**Comanche Peak Nuclear Power Plant, Units 3 & 4
COL Application**

FSAR Revision 3

Update Tracking Report

Revision 2

Figure 8.3.1-1R Onsite AC Electrical Distribution System (Sheet 1 of 78)
Main One Line Diagram

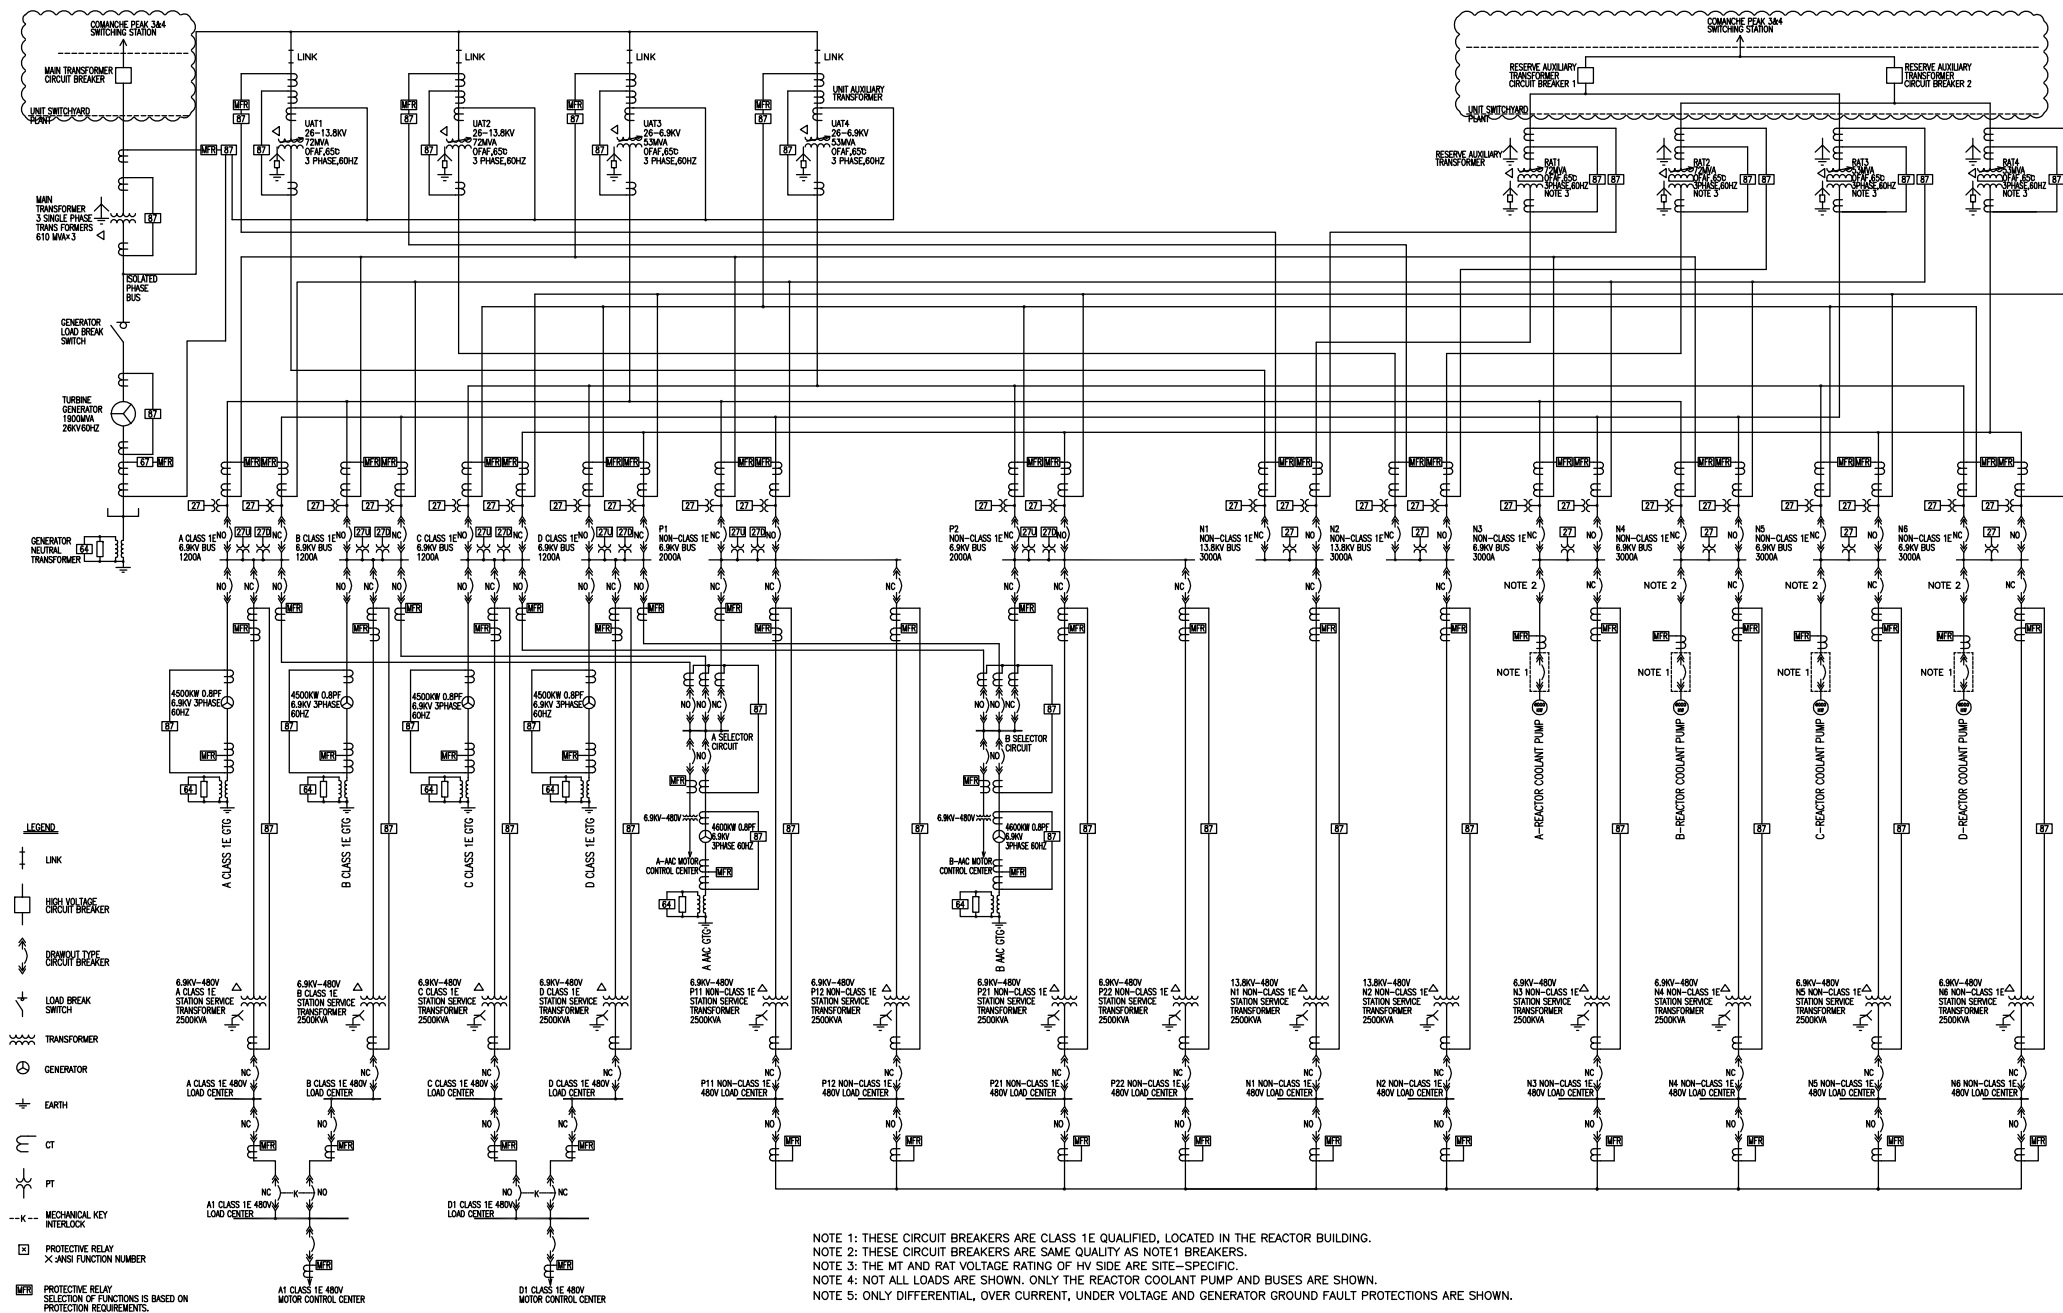
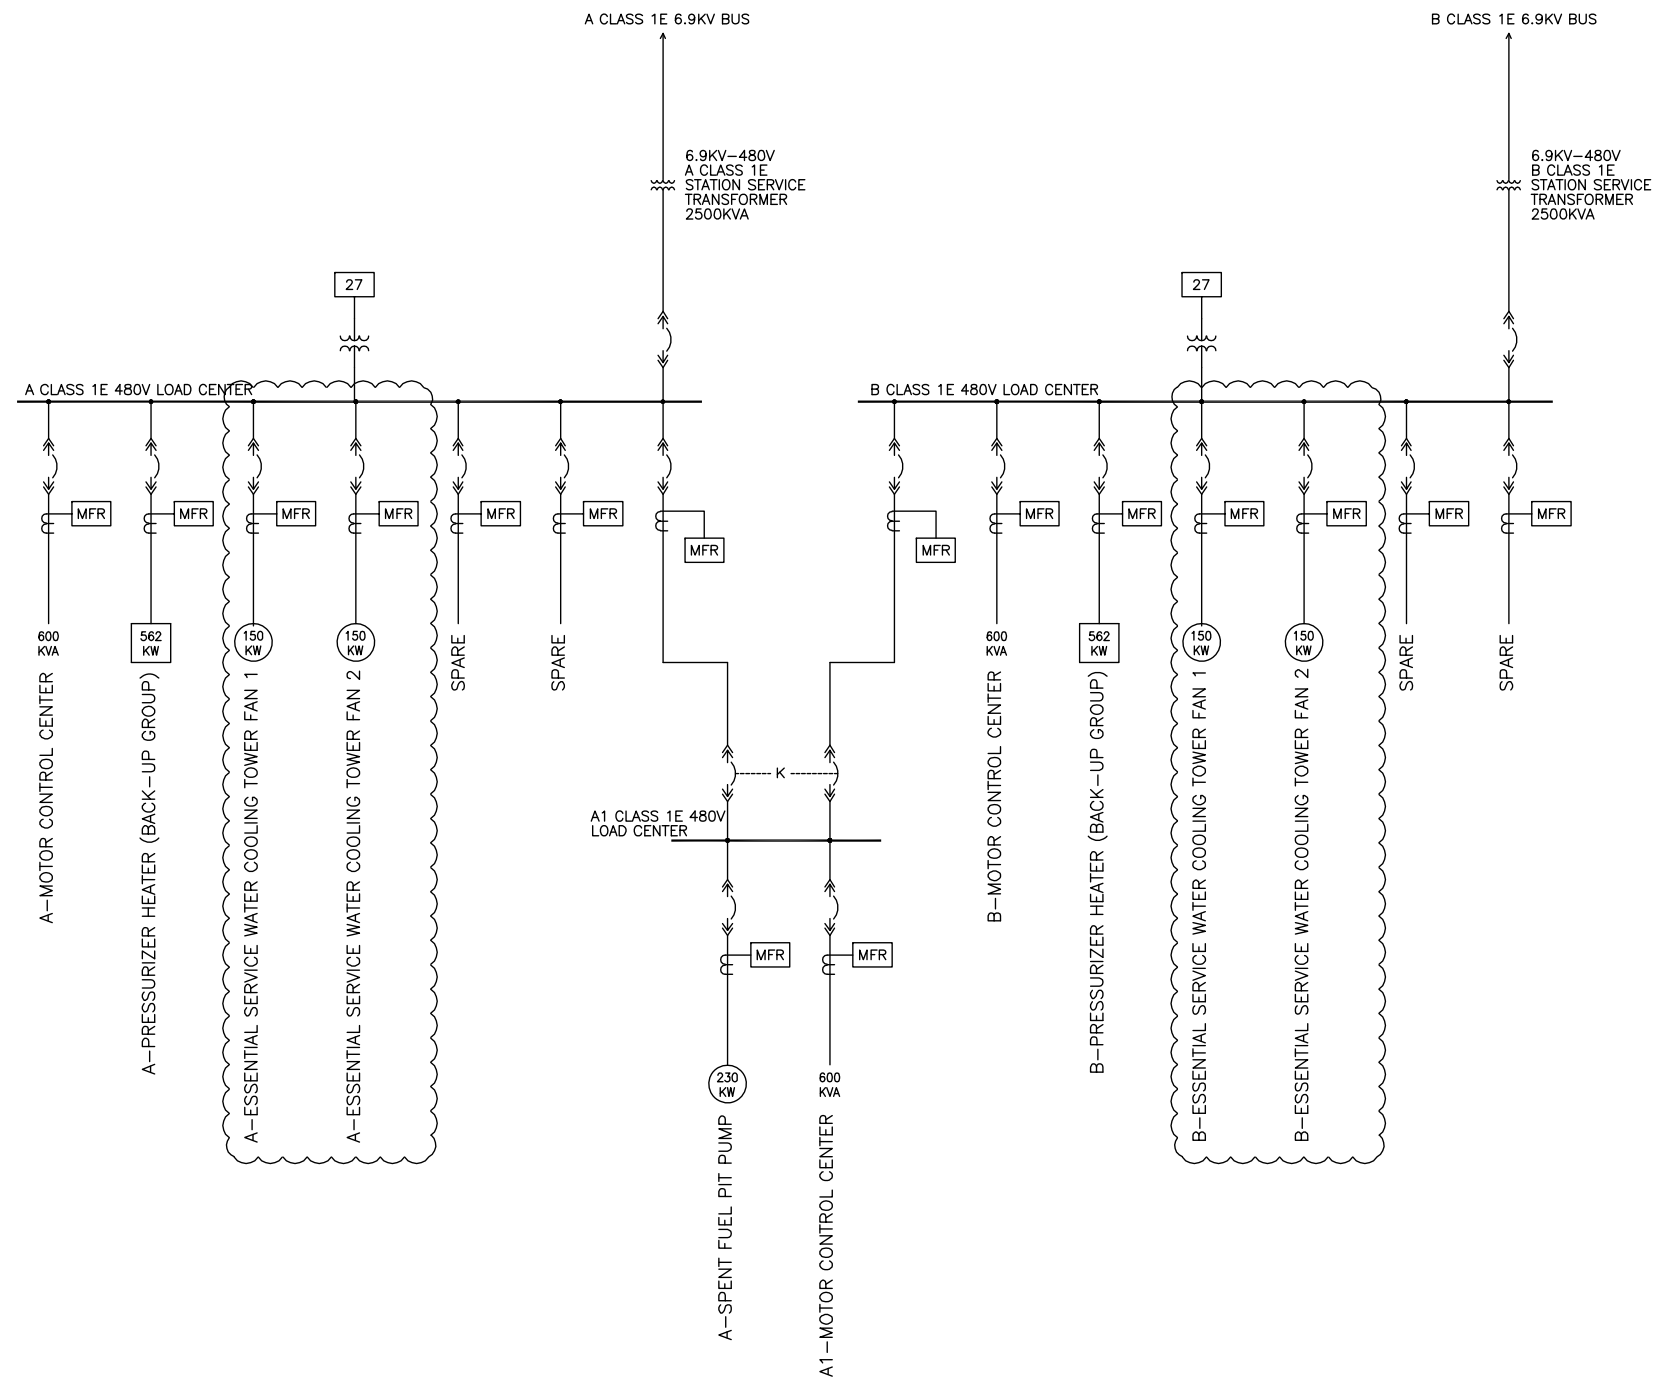
CTS-01532

**Figure 8.3.1-1R Onsite AC Electrical Distribution System (Sheet 6 of 78)
Class 1E 480V Buses C and D One Line Diagram**

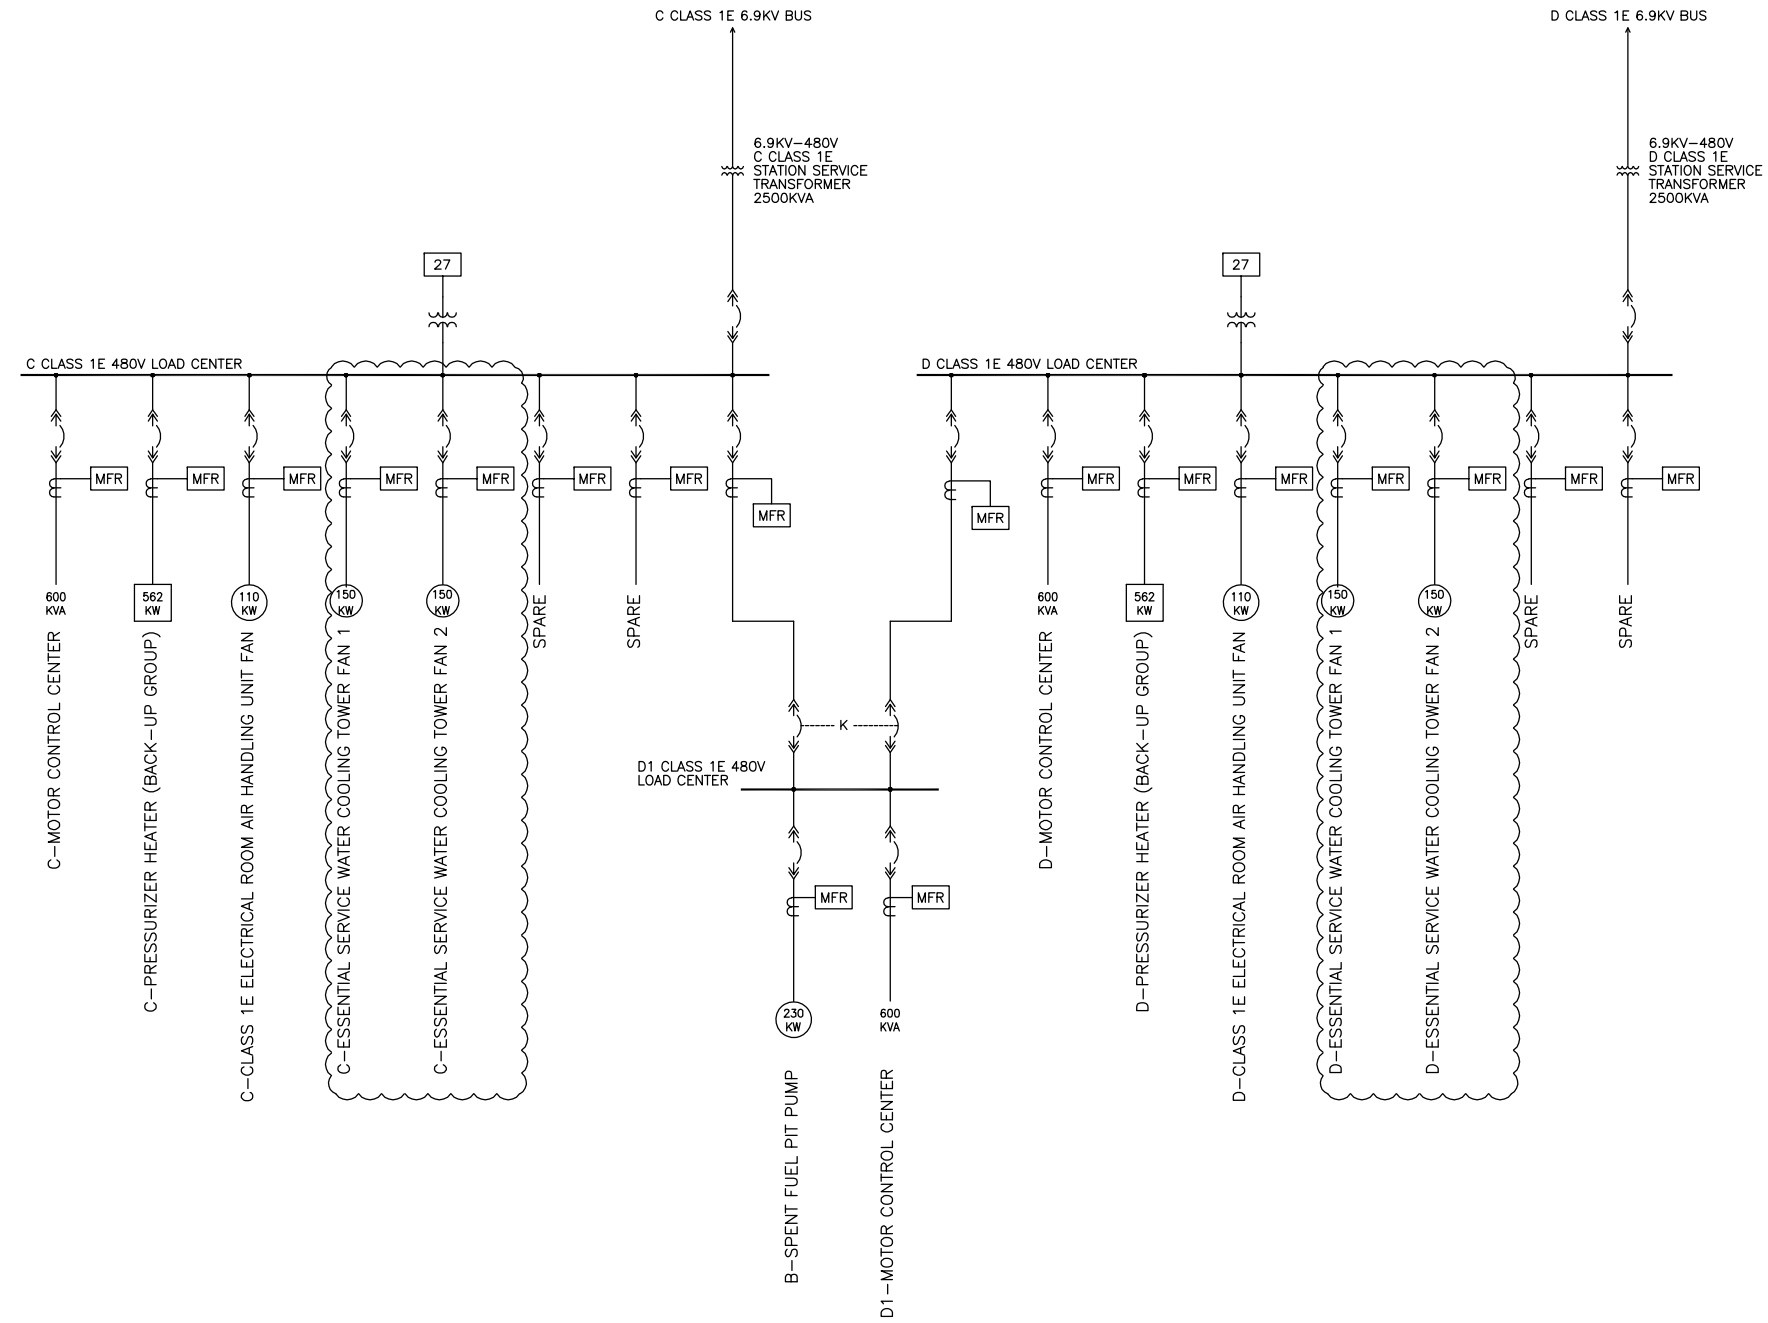
CTS-01532

Figure 8.3.1-2R Logic Diagrams (Sheet 2 of 24)
One Line Diagram

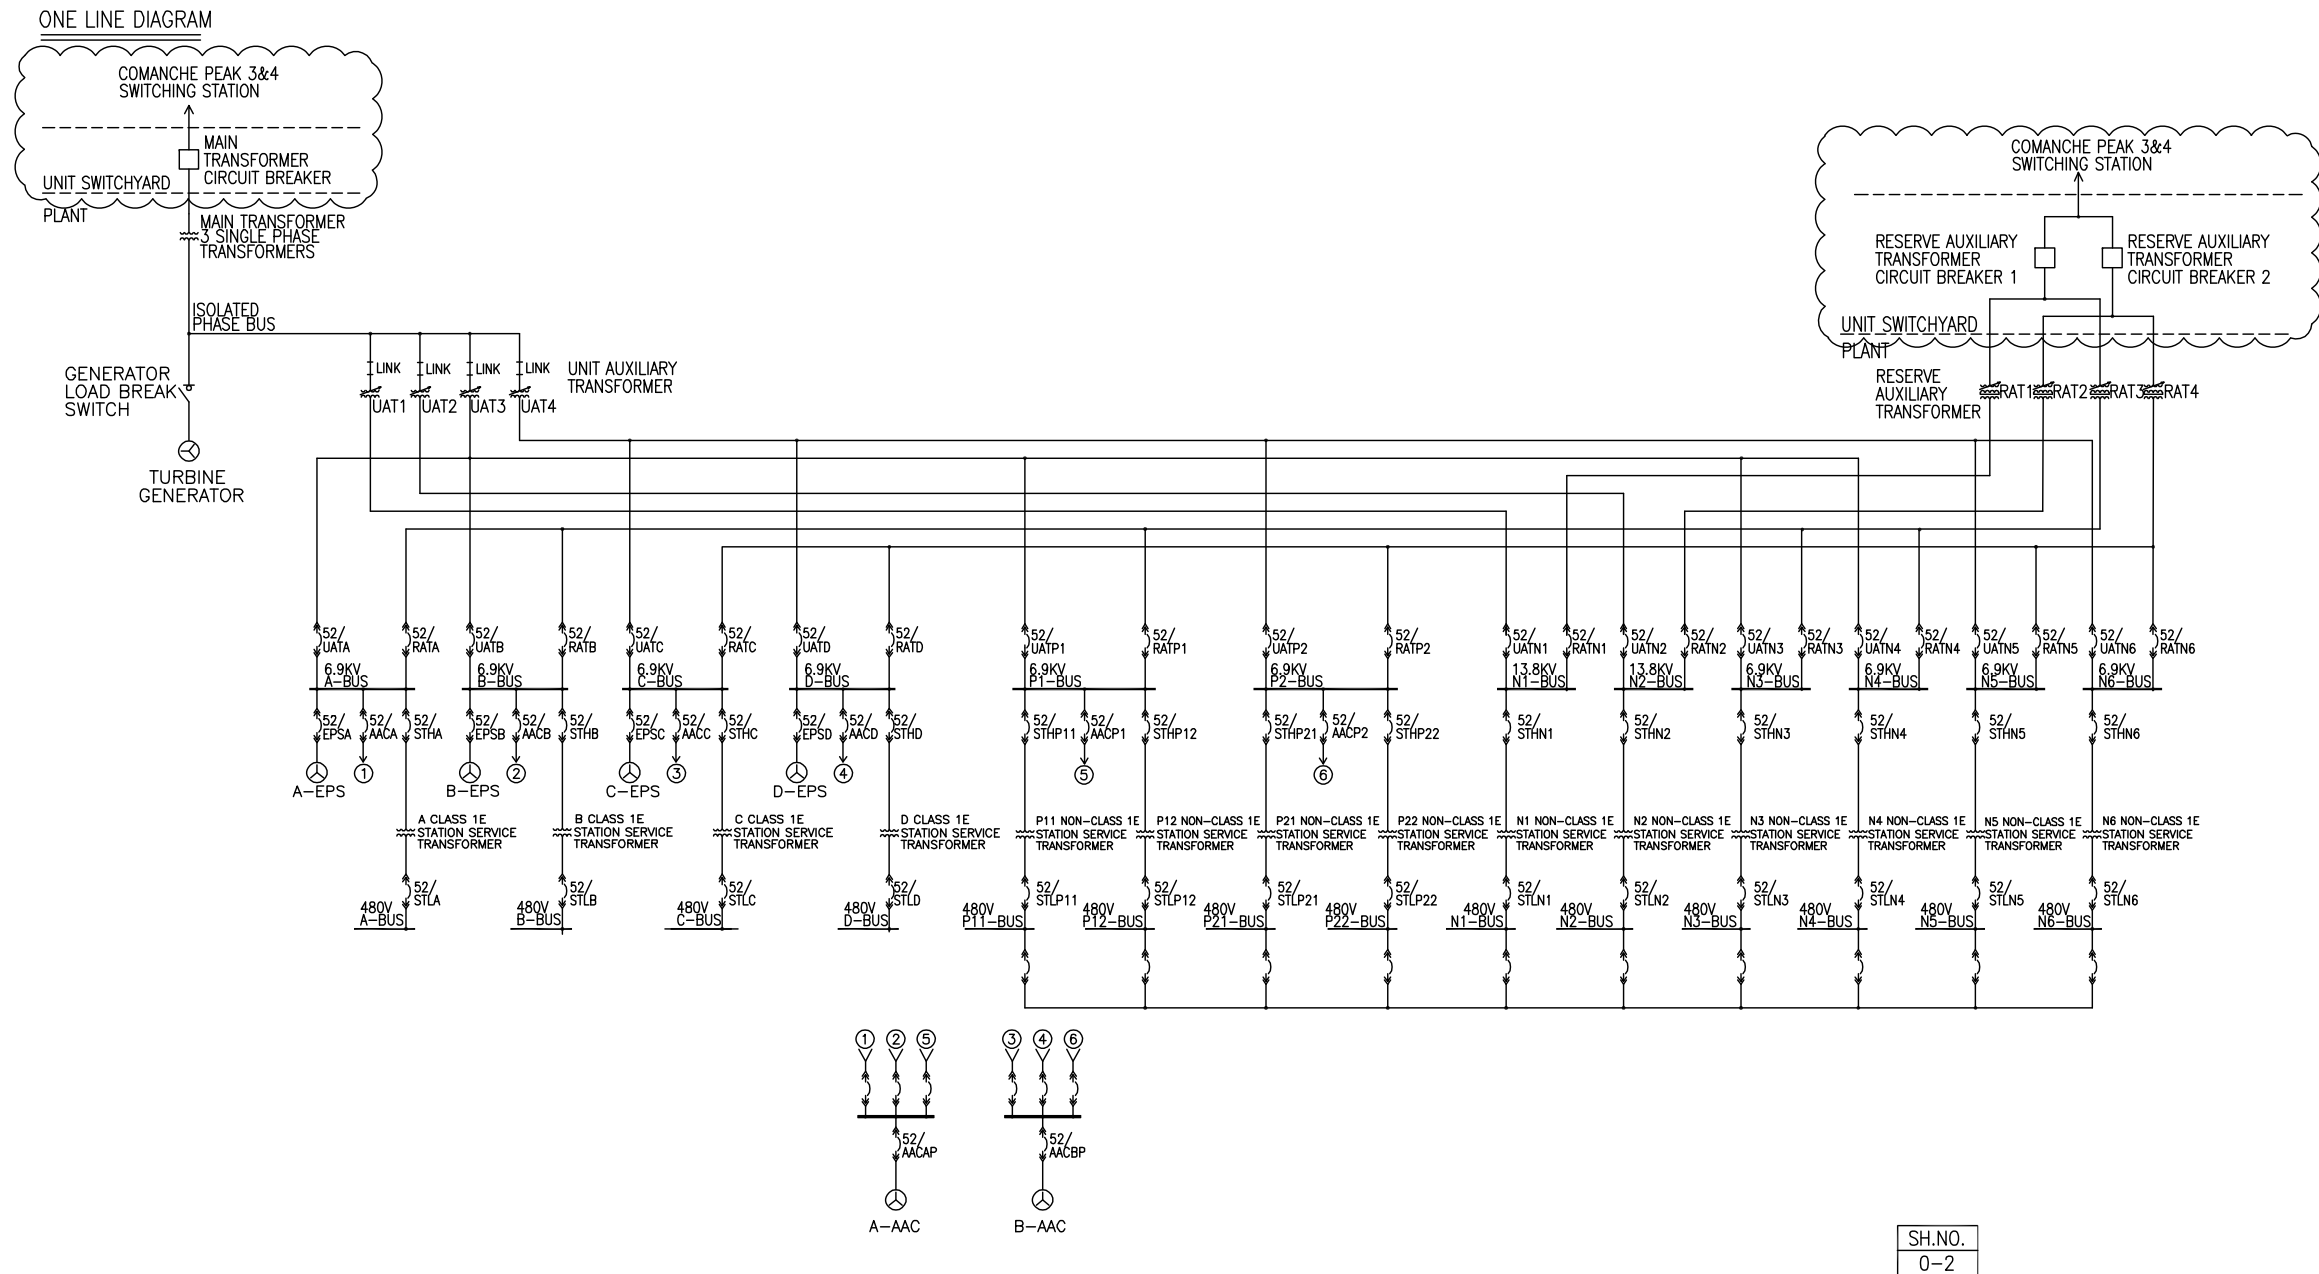
CTS-01532
